2019/04/10

MAFR300 series Z Type Bracket Change Notification

MAFR300.

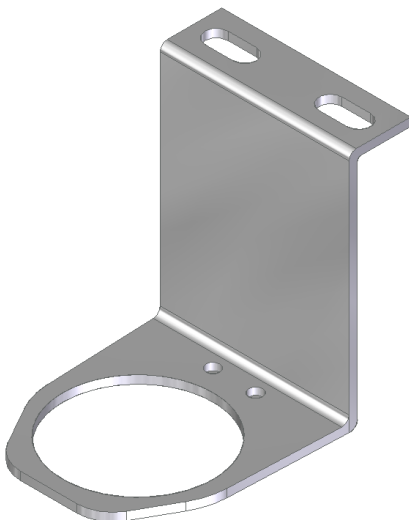
In response to market demand, Z type bracket change surface treatment will be changed from black electrophoretic to nickel plated.
